Harker Heights

IPC Chapter 1

~CHANGES FROM THE 2015-2018 CODES

~ CITY AMENDMENTS

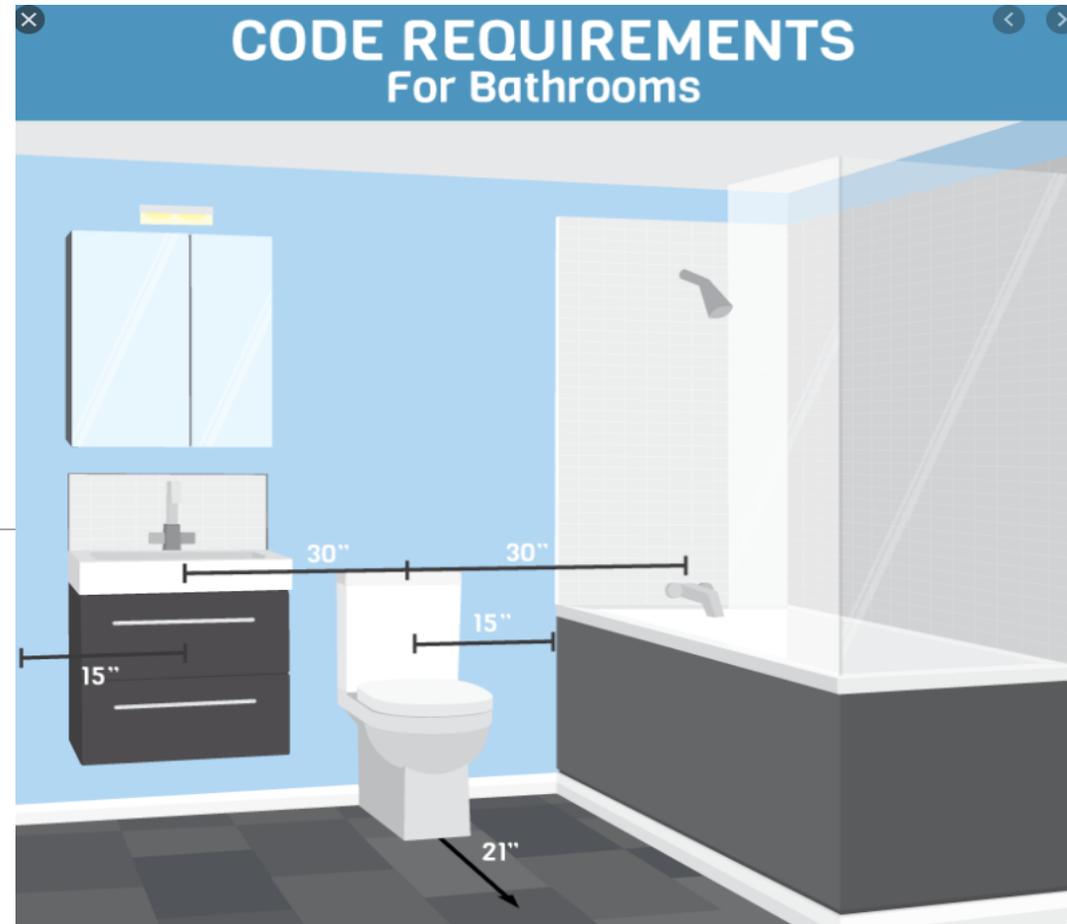
305.6 PROTECTION AGAINST PHYSICAL DAMAGE. IN CONCEALED LOCATIONS WHERE PIPING IS INSTALLED THROUGH HOLES OR NOTCHES IN STUDS, JOISTS, RAFTERS OR SIMILAR MEMBERS LESS THAN ~~1 1/2~~ **1 1/4**. (CHANGE MADE 2015 TO 2018. NO CHANGE 2021)

SECTION 504.7.3 PAN DRAIN TERMINATION.

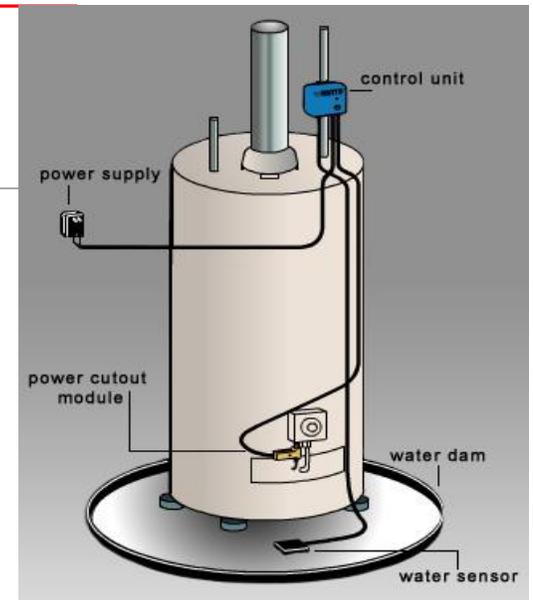
ADD NEW SECTION TO SAY: “AN APPROVED WARNING AND WATER SERVICE SHUTOFF DEVICE SHALL BE REQUIRED WHERE THE PAN DRAIN TERMINATION IS NOT TAKEN TO THE OUTSIDE.”

SECTION 603.2 SEPARATION OF WATER SERVICE AND BUILDING SEWER.

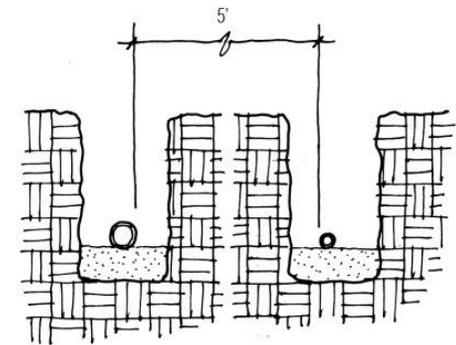
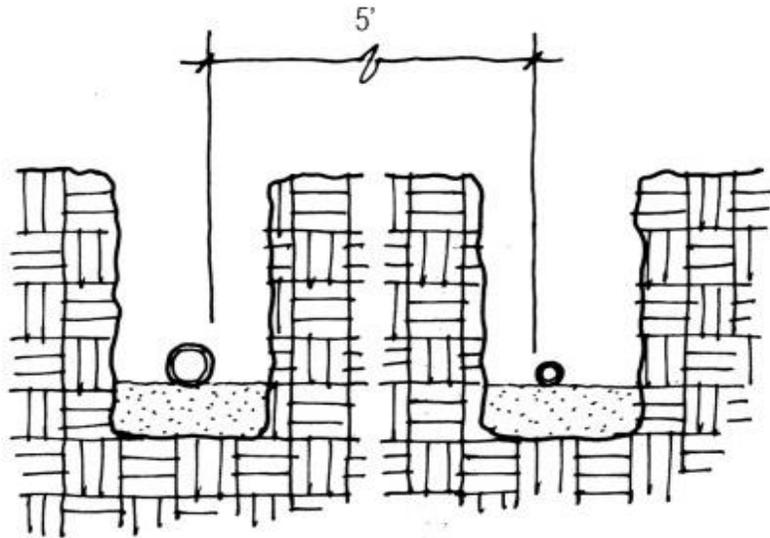
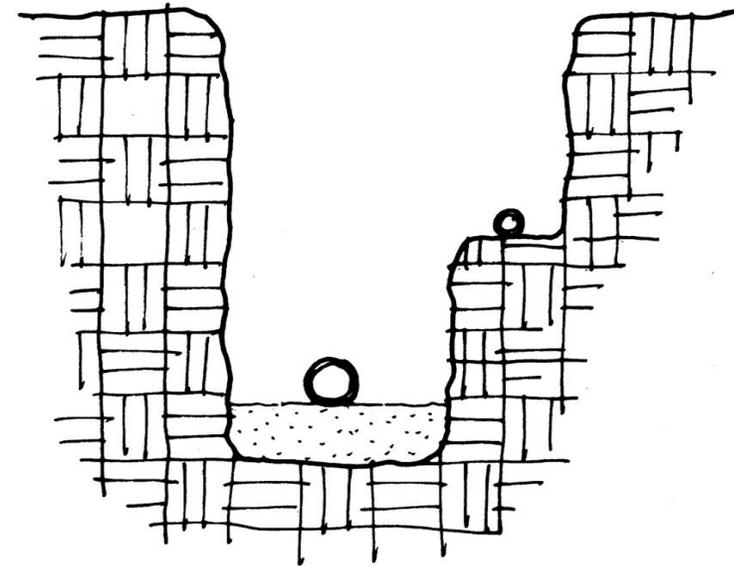
DELETE FIRST SENTENCE AND CHANGE TO READ: "THE BUILDING SEWER SHALL BE HORIZONTALLY SEPARATED BY NOT LESS THAN 5 FEET (1,524 MM) OF UNDISTURBED OR COMPACTED EARTH. THE REQUIRED SEPARATION DISTANCE SHALL NOT APPLY WHERE A WATER SERVICE PIPE CROSSES A SEWER PIPE, PROVIDED THE WATER SERVICE IS SLEEVED TO A POINT NOT LESS THAN 5 FEET (1,524 MM) HORIZONTALLY FROM THE SEWER PIPE CENTERLINE ON BOTH SIDES OF SUCH CROSSING. THE SLEEVE SHALL BE OF PIPE MATERIALS LISTED IN TABLE 605.3, 702.2 OR 702.3. THE REQUIRED SEPARATION SHALL NOT APPLY WHERE THE BOTTOM OF THE WATER SERVICE PIPE, LOCATED WITHIN 5 FEET (1,524 MM) OF THE SEWER, IS NOT LESS THAN 12 INCHES (305 MM) ABOVE THE HIGHEST POINT OF THE BUILDING SEWER."

SECTION 717 RELINING BUILDING SEWERS AND BUILDING DRAINS

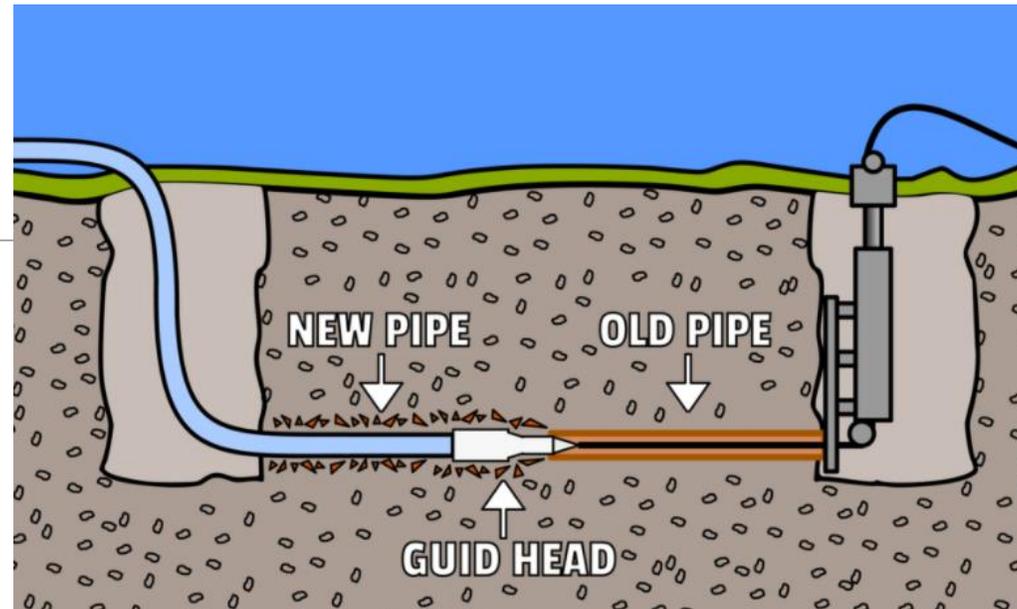
CHANGE 2018-2021: ADDED SECTION FOR TRENCHLESS PIPE RESTORATION TECHNOLOGIES.

SECTION 903 VENT TERMINALS

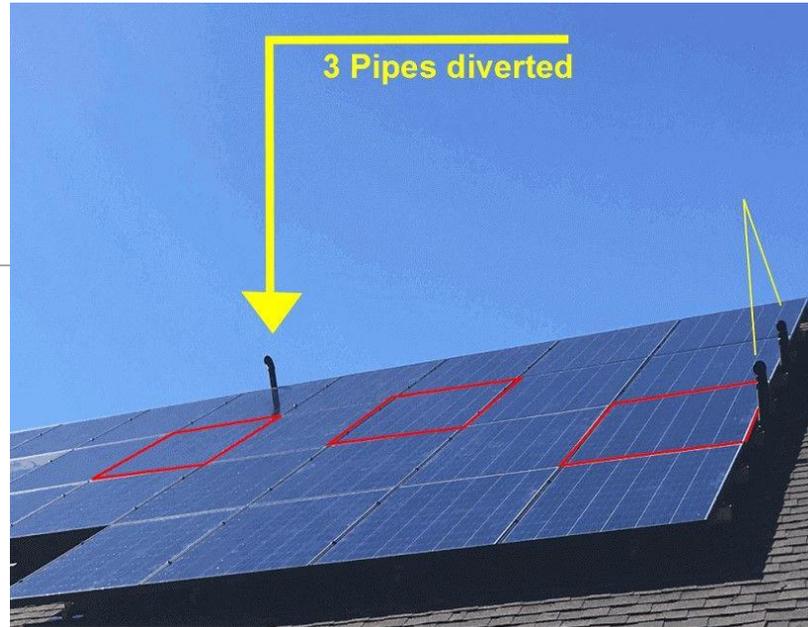
903.1.3 PROTECTED VENT TERMINAL. WHERE AN OPEN VENT PIPE TERMINATES ABOVE A SLOPED ROOF AND IS COVERED BY EITHER A ROOF-MOUNTED PANEL (SUCH AS A SOLAR COLLECTOR OR ~~PHOTOVOLTAIC PANEL MOUNTED OVER THE VENT OPENING~~) OR A ROOF ELEMENT (SUCH AS AN ARCHITECTURAL FEATURE OR A DECORATIVE SHROUD), THE VENT PIPE SHALL TERMINATE NOT LESS THAN 2 INCHES (51 MM) ABOVE THE ROOF SURFACE

503.5.6.1 CHIMNEY LINING. CHIMNEYS SHALL BE LINED IN ACCORDANCE WITH NFPA 211.

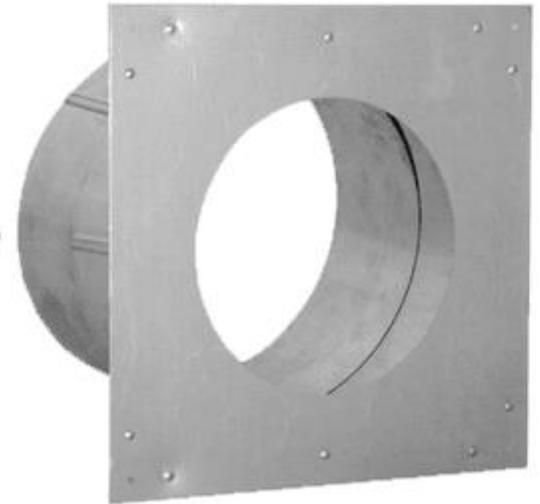
CHANGE IN THE 2021. REMOVED EXCEPTION. WAS CONSIDERED OUTDATED.

~~EXCEPTION: WHERE AN EXISTING CHIMNEY COMPLIES WITH SECTIONS 503.5.6 THROUGH 503.5.6.3 AND ITS SIZING IS IN ACCORDANCE WITH SECTION 503.5.5, ITS CONTINUED USE SHALL BE ALLOWED WHERE THE APPLIANCE VENTED BY SUCH CHIMNEY IS REPLACED BY AN APPLIANCE OF SIMILAR TYPE, INPUT RATING AND EFFICIENCY.~~
